**REMARKS**

**II. Amendments to the Drawings**

PRIOR ART  
**FIG. 1**

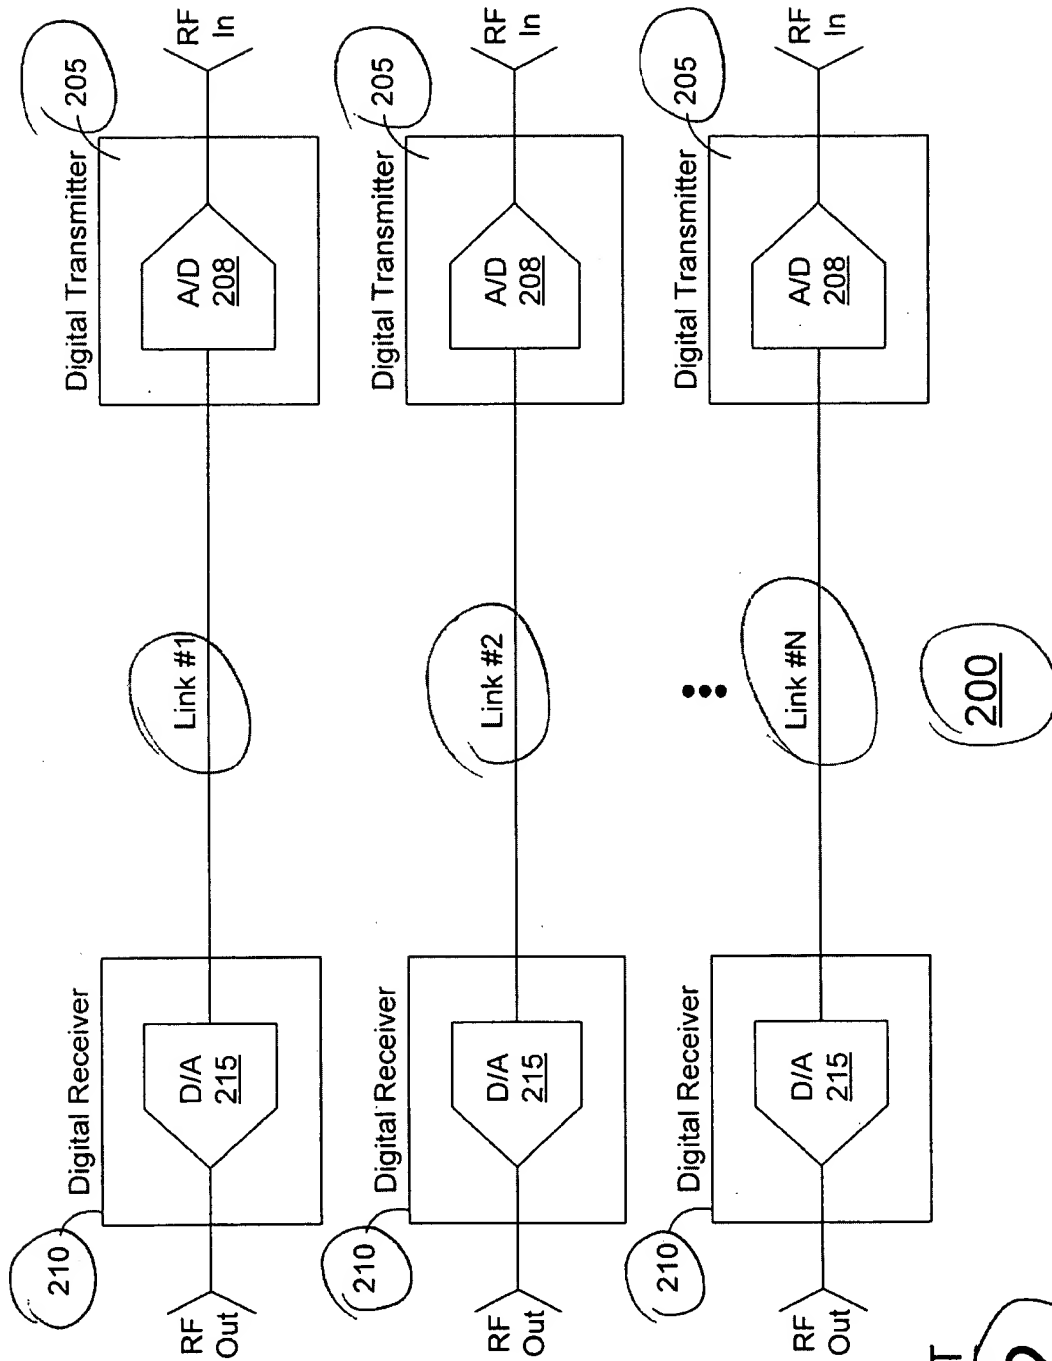
Amendments to Figure 1 are marked in red on sheet 1/6 of the attached Annotated Sheet of drawings. The amendments to FIG. 1 have been made so that the FIG. 1 accurately depicts what is described in the Specification at page 1, lines 16-30 by providing correct reference numbers in the drawings. The changes to FIG. 1 are fully supported in the Specification at page 1, lines 16-30, and no new matter has been added.

FIG. 2

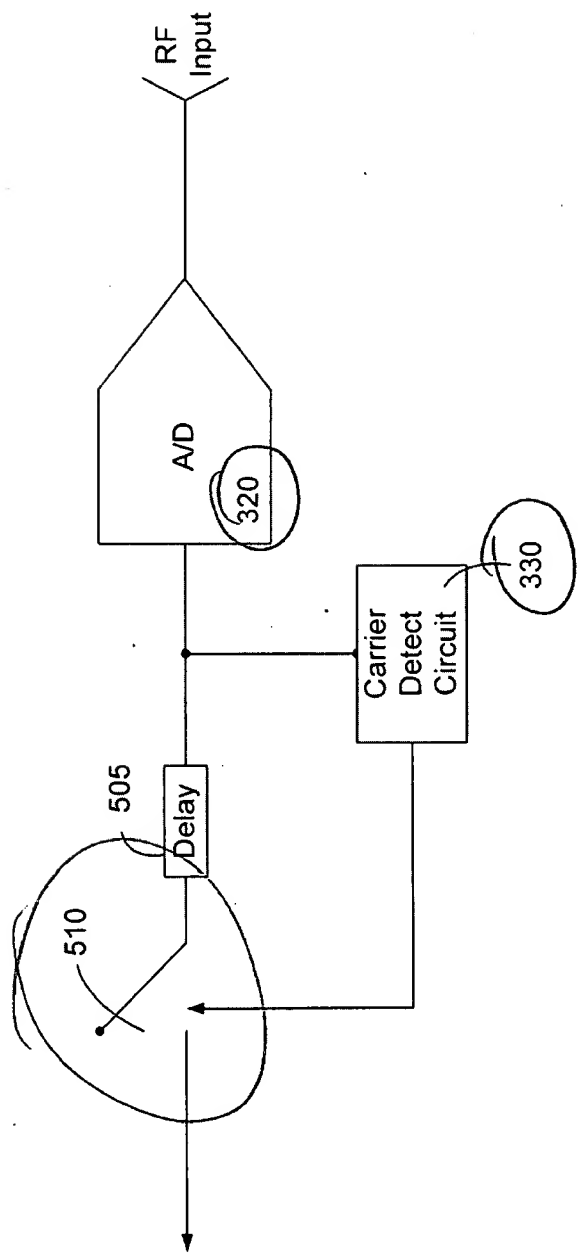
Replacement sheet 2/6 is being submitted to correct errors in originally filed FIG. 2. Amendments to Figure 2 are marked in red on sheet 2/6 of the attached Annotated Sheet of drawings. Originally filed FIG. 2 was submitted in this application in error, which is readily apparent upon inspecting the description of FIG. 2 in the originally filed specification. By this amendment is effectively being deleted from the application and being replaced by Replacement FIG. 2. The description of FIG. 2 in the specification beginning at page 2, line 5, describes what is depicted in originally filed Figure 3 (sheet 3/6), but originally filed FIG. 3 has its reference numbers increased by adding 100. Accordingly, the replacement sheet 2/5 for FIG. 2 is substantially identical to originally filed Figure 3, but has its reference numbers decreased by subtracting 100. Support for this Amendment can be found in originally filed FIG. 3 and in the Specification at page 2, lines 5-20. No new matter is being added by this amendment.
